Project	IEEE 802.16 Broadband Wireless Access Working Group < http://ieee802.org/16 >	
Title	Correction to AMC pilot pattern definition	
Date Submitted	2005-05-05	
Source(s)	Yuval Lomnitz Uri Perlmutter Dov Andelman Intel.	Yuval.Lomnitz@intel.com Uri.PerlMutter@intel.com Dov.Andelman@intel.com
Re:	IEEE P802.16e/D7	
Abstract	Correction to AMC pilot pattern definition	
Purpose	Adopt changes	
Notice	This document has been prepared to assist IEEE 802.16. It is offered as a basis for discussion and is not binding on the contributing individual(s) or organization(s). The material in this document is subject to change in form and content after further study. The contributor(s) reserve(s) the right to add, amend or withdraw material contained herein.	
Release	The contributor grants a free, irrevocable license to the IEEE to incorporate material contained in this contribution, and any modifications thereof, in the creation of an IEEE Standards publication; to copyright in the IEEE's name any IEEE Standards publication even though it may include portions of this contribution; and at the IEEE's sole discretion to permit others to reproduce in whole or in part the resulting IEEE Standards publ

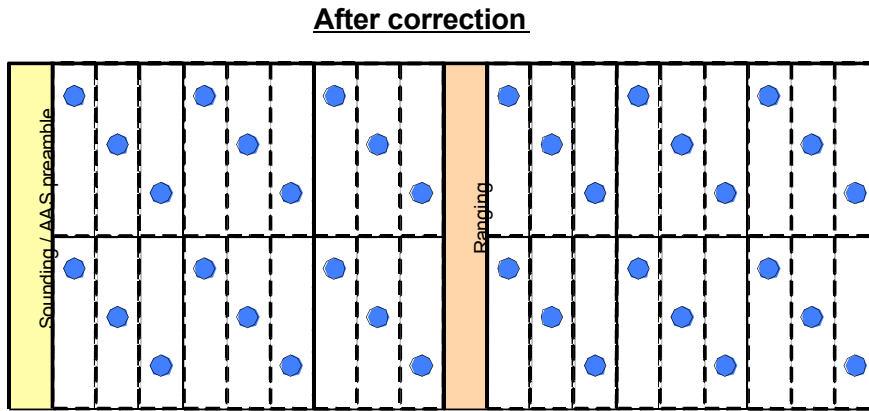
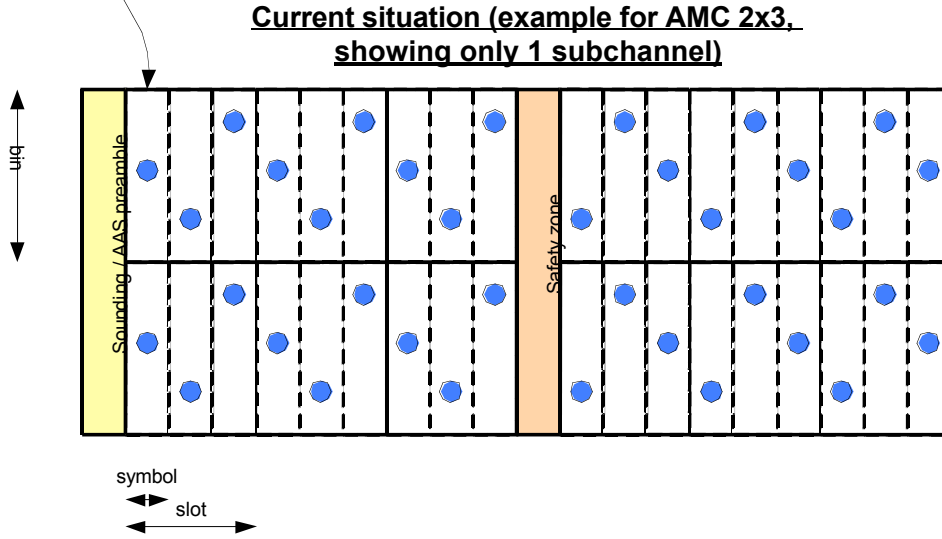
The AMC pilot location is based on symbol index from beginning of zone ($9k+3m+1$). This definition doesn't take into account special symbols (preamble, sounding, etc).

- In the UL, there are symbols in which are entirely filled by rectangular allocations (e.g. Sounding, Ranging (not in AMC), Safety/PAPR reduction zones). In these symbols there are no slots, and the counting of slots resumes after these symbols (see clarifications done in 802.16Cor1/D2, 8.4.4.5). The current AMC pilot structure ignores this fact, so although the actual data contents (slots) is shifted, the pilots remain in same locations, which means that they move relative to the data slots, as shown in diagram below.
- In the DL, MIMO preamble or AAS preambles may cause similar phenomenon, of shifting the pilot pattern (or more accurately shifting the data subcarriers without similar shift of pilots).

Initial phase depends on number of symbols in DL subframe

The simplest way is to define m as symbol offset from start of slot epoch, but in order to be consistent with OFUSC and with all AMC tile structures, we propose to define that m is the symbol offset from the start of the current zone, counting only data symbols (i.e. Safety zones, Sounding symbols, preambles, etc are not counted).
